18-4143-00: Hot Springs, AR 2025 SSES

Smoke Observation Summary

Cleanout, Missing/Broken Cap

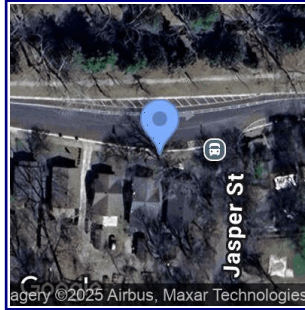
QC Comments: confirm where cleanout defect is - possibly above grade and 0 drainage area - EE
